<b>PROJECT:</b>	City Impact	<b>PROJECT NO.</b>	L11118
<b>FROM:</b>	BVH - Dennis Coudriet	<b>DATE:</b>	12.3.13
<b>TO:</b>	Brester Construction	<b>ADDENDUM NO.</b>	Two

**SK-1**

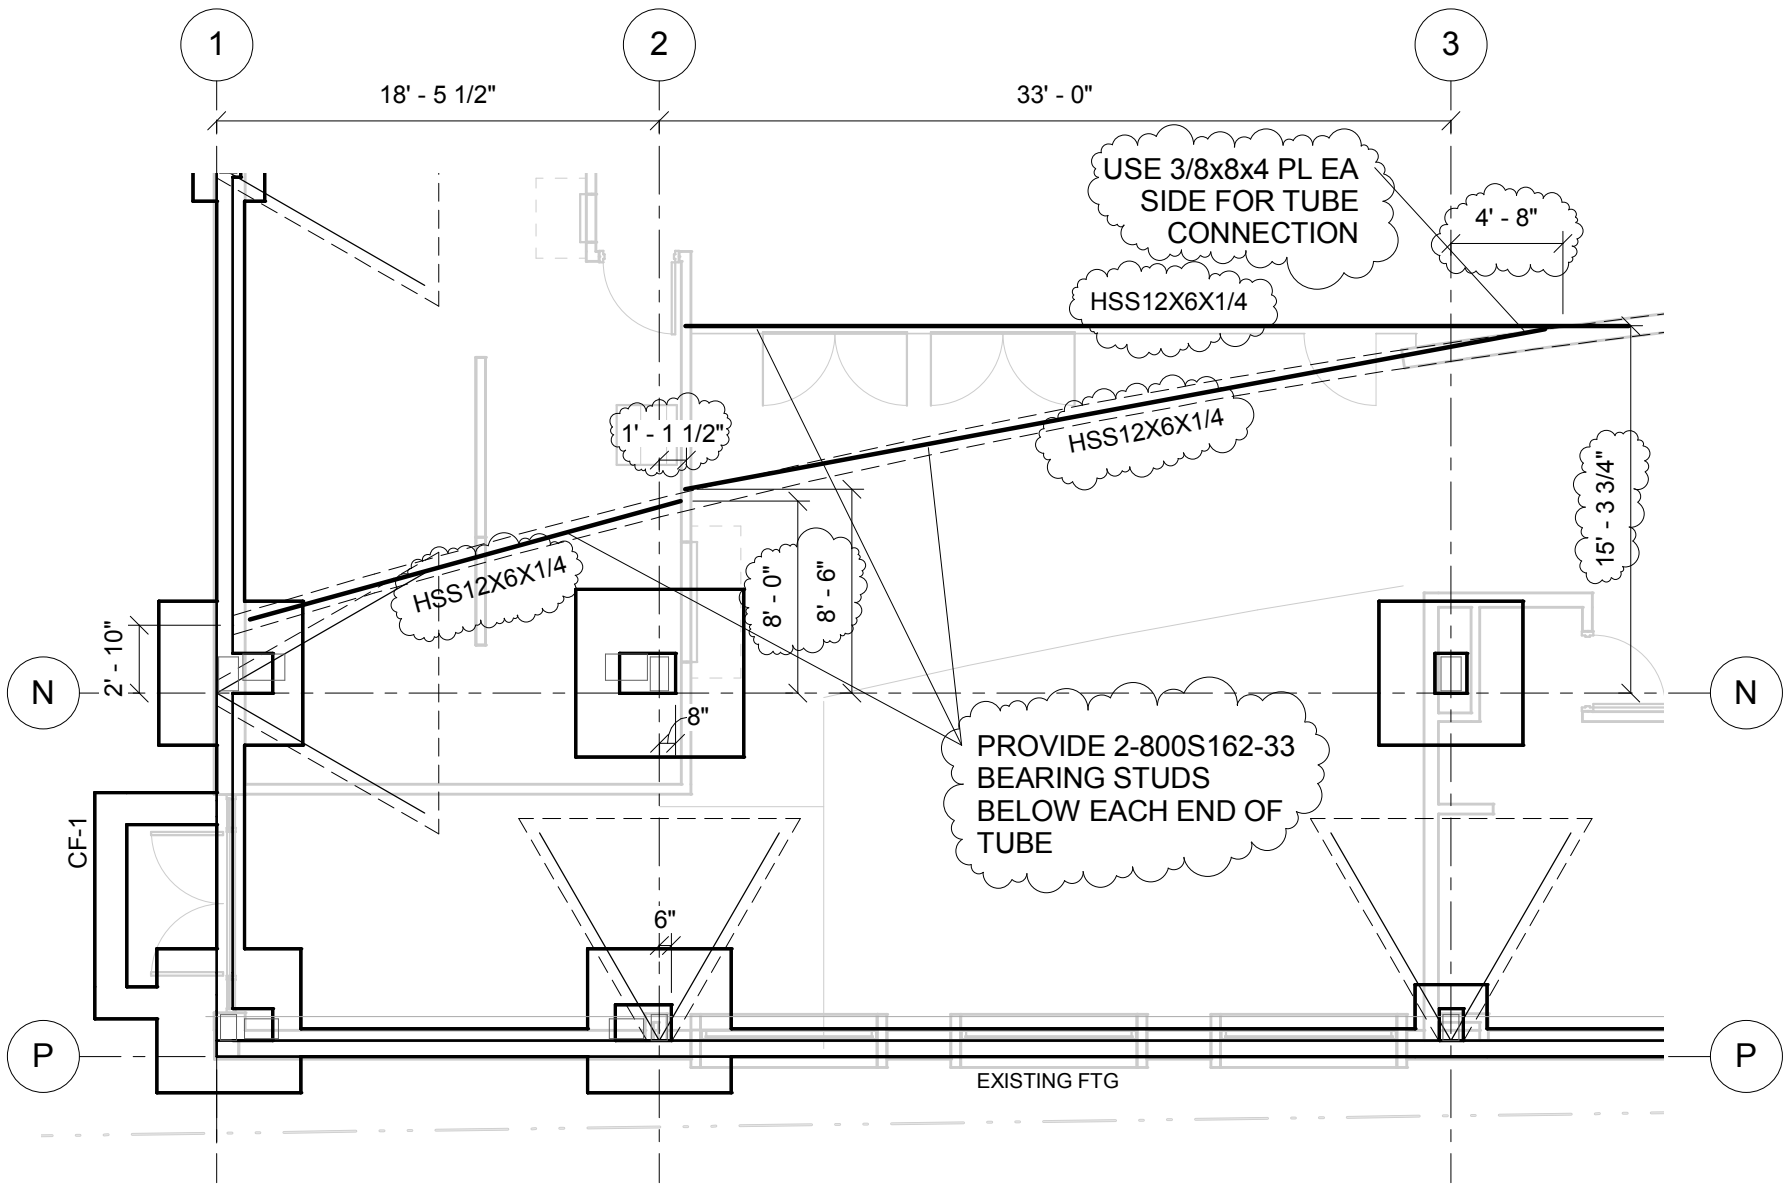
3. See attached structural sheets for revisions and clarifications.
